# Access Compliance Report

## Public Rights-of-Way

### (Curb Ramps)

Intersection ID: 6594	Main Street: DALE_AV	Cross Street: ROOK_RD	Location: S
ADA ID: 026CC5FFD9A8	Ramp Type: PerpDiag	Initial Pass/Fail: Fail	Overall Compliance: No
Severity Score: 12.5			
Codes/Mitigation Info/Possible Solution		Field Measurements/Component Compliance

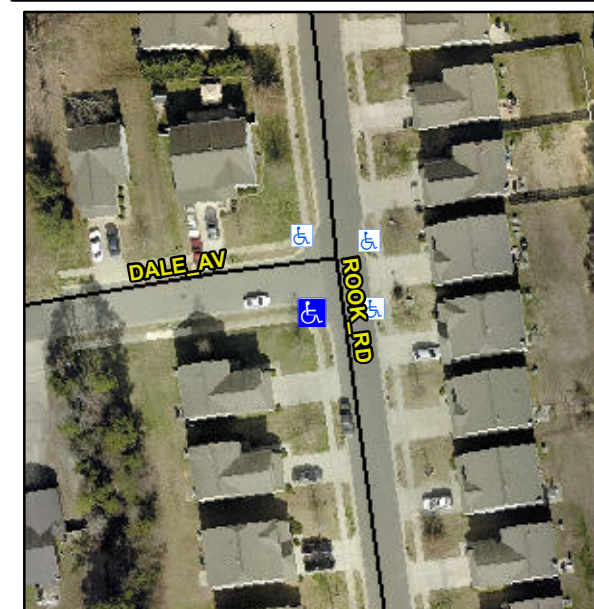
**Not Found, R304.2.2**

Compliance	Description	Data	Compliance	Description	Data
N/A	Ramp Length (in)	47.0	No	Ramp Slope (%)	8.5
Yes	Ramp Width (in)	48.0	Yes	Ramp XSlope (%)	1.5
N/A	Flare Type LT	N/A	N/A	Flare Type RT	N/A
N/A	Flare Slope LT (%)	N/A	N/A	Flare Slope RT (%)	N/A
N/A	Flare Traversable LT?	N/A	N/A	Flare Traversable RT?	N/A
N/A	Landing Length (in)	N/A	N/A	DWS Provided?	N/A
N/A	Landing Width (in)	N/A	N/A	DWS Contrast?	N/A
N/A	Landing Slope (%)	N/A	N/A	DWS Length (in)	N/A
N/A	Landing X Slope (%)	N/A	N/A	DWS Full Width?	N/A
N/A	Landing Curb? (Y/N)	N/A	N/A	DWS Offset (in)	N/A
N/A	Shared Landing?	N/A			
N/A	Gutter Ponding?	N/A	N/A	Gutter Slope (%)	N/A
N/A	Gutter Lip Ht (in)	N/A	N/A	Gutter X Slope (%)	N/A
N/A	Painted X Walk1?	No	N/A	Painted X Walk2?	No
	X Walk 1 Direction	To N		X Walk 2 Direction	To W
N/A	X Walk 1 Width (in)	N/A	N/A	X Walk 2 Width (in)	N/A
	X Walk 1 Slope (%)	0.2		X Walk 2 Slope (%)	2.1
	X Walk 1 X Slope (%)	2.9		X Walk 2 X Slope (%)	2.1

**Remove & Replace Curb Ramp With Two New Directional Ramps or Equivalent.**
